**1958 Agreement – Consideration of draft amendments  
to existing Regulations submitted by GRE**

### **Proposal for the 04 series of amendments to Regulation No. 27 (Advance warning triangles)**

#### **Submitted by the Working Party on Lighting and Light-Signalling \***

**Shape and dimensions of the advance-warning triangle of type 1 and of the support**

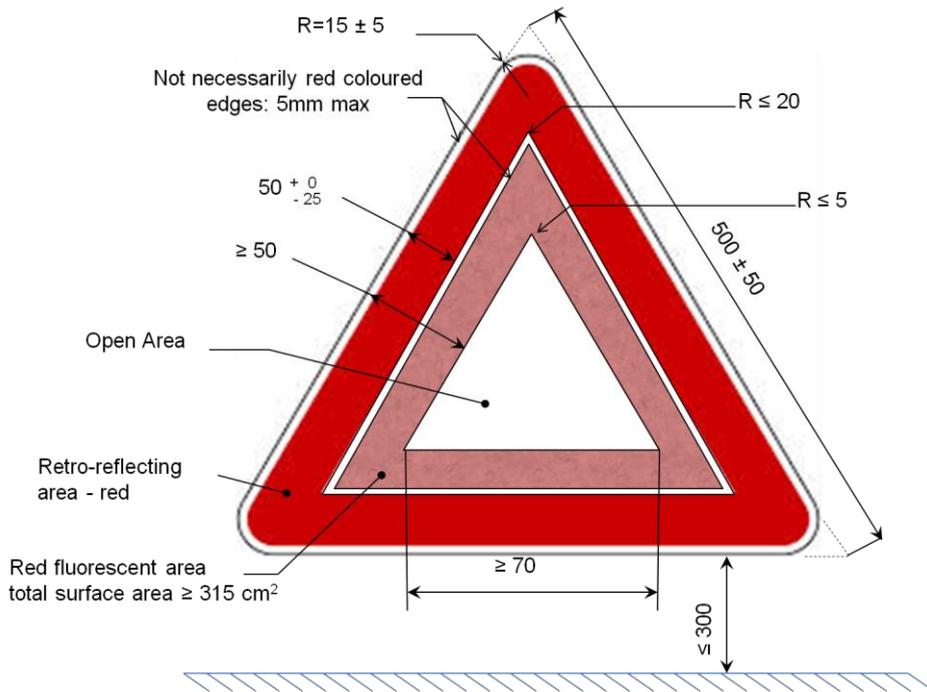
*Annex 3, figure 1., amend to read:*

"Figure 2  
Shape and dimensions of the advance-warning triangle of type 2 and of the support

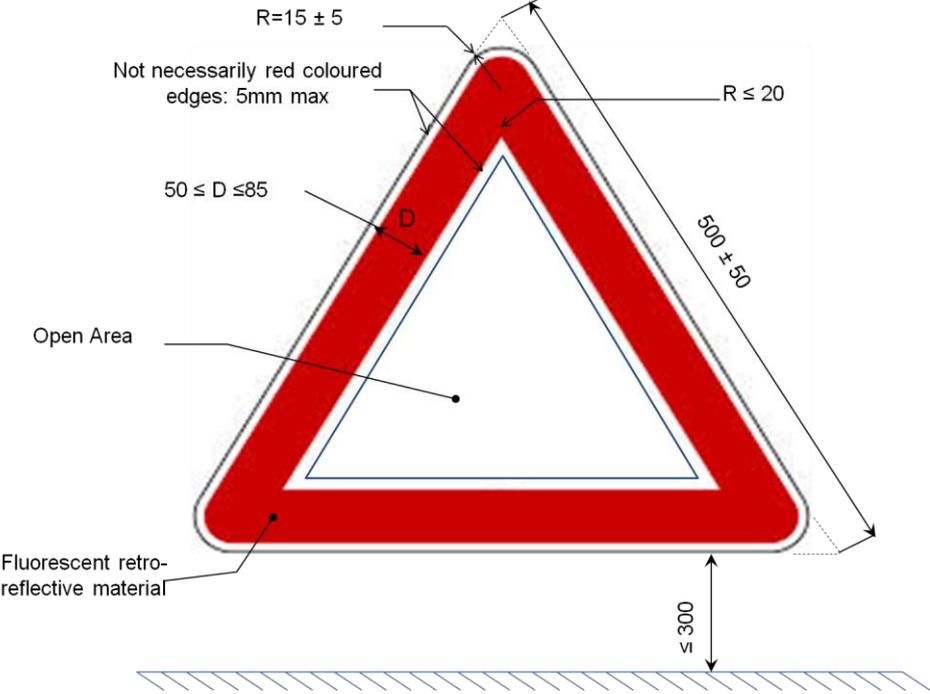
Insert a new Figure 2, to read

"Figure 3  
Test device for clearance to ground

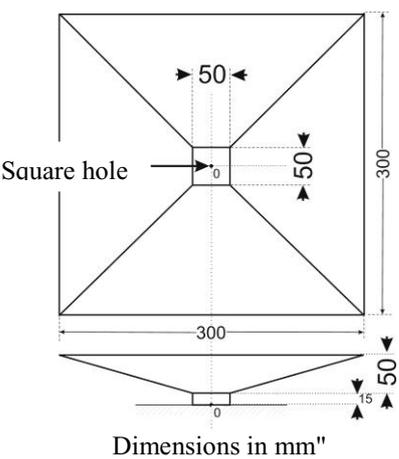
Annex 3, Figure 2 (former), renumber as Figure 3 and amend to read:
